# Errata Sheet

July 7, 2003 / Release 1.2

<b>Device:</b>	<b>SAK-C167CS-LM SAK-C167CS-L33M SAK-C167CS-L40M SAK-C167CS-4RM SAK-C167CS-4R33M SAK-C167CS-4R40M</b>
<b>Stepping Code / Marking:</b>	<b>ES-BA, BA, BA 6</b>
<b>Package:</b>	<b>P-MQFP-144-1, P-MQFP-144-6 (BA 6)</b>

#### New value of the PLL jitter

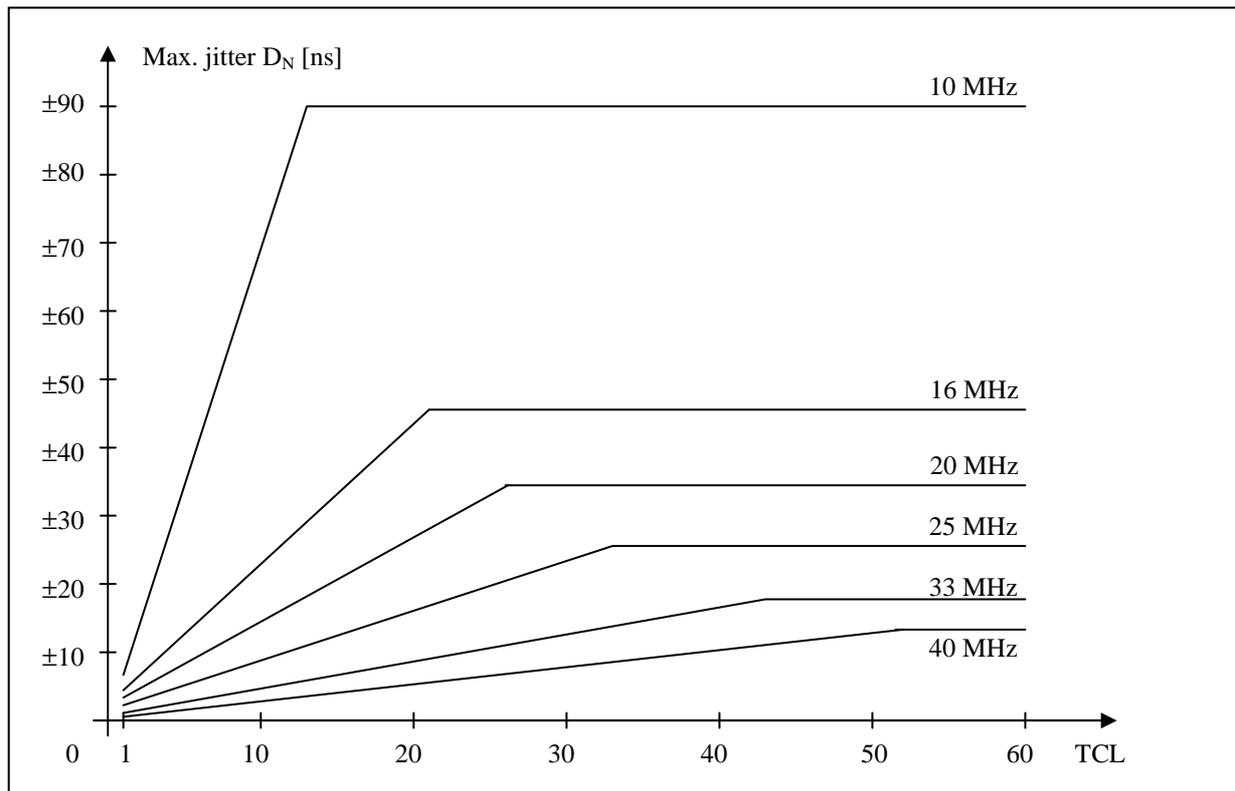
### PLL.3.3: Increased PLL Jitter caused by external Access

In systems where the PLL is used for generation of the CPU clock frequency, the PLL jitter can increase under certain circumstances and exceed the specified value.

The value of the additional jitter is not a fixed one but it depends on the kind of activity on the external bus or output pins. The additional jitter increases with the number of output/bus pins which are switched at the same time to a new voltage level because the problem is caused by noise on the on-chip power supply.

All PLL factors are affected (PLL factor 1.5 / 2 / 2.5 / 3 / 4 / 5). The PLL jitter increases when access to the external bus or output pins is performed. This phenomenon has no influence to direct drive-, prescaler-, and SDD mode.

The additional jitter has the maximum effect if only one TCL is considered (period jitter). This can have an influence to the bus timings with one TCL.

For an accumulated period of  $N \cdot \text{TCL}$  the new maximum jitter  $D_N[\text{ns}]$ , which exceeds the specified value in the Data Sheet, is computed using the formula:

$$D_N[\text{ns}] = \pm((460 / f_{\text{CPU}} + 4366 / f_{\text{CPU}}^2) * (N / T_m) + 0.25)$$

Were  $N$  = number of consecutive TCL,  $f_{\text{CPU}}$  = CPU frequency in MHz and  $T_m = f_{\text{CPU}} * 1.3$  .

This approximated formula is valid for a CPU frequency  $10 \text{ MHz} \leq f_{\text{CPU}} \leq 40 \text{ MHz}$  with the conditions:

$$\begin{aligned} T_m &= f_{\text{CPU}} * 1.3 && \text{for } N \leq T_m \\ T_m &= N && \text{for } N > T_m \end{aligned}$$
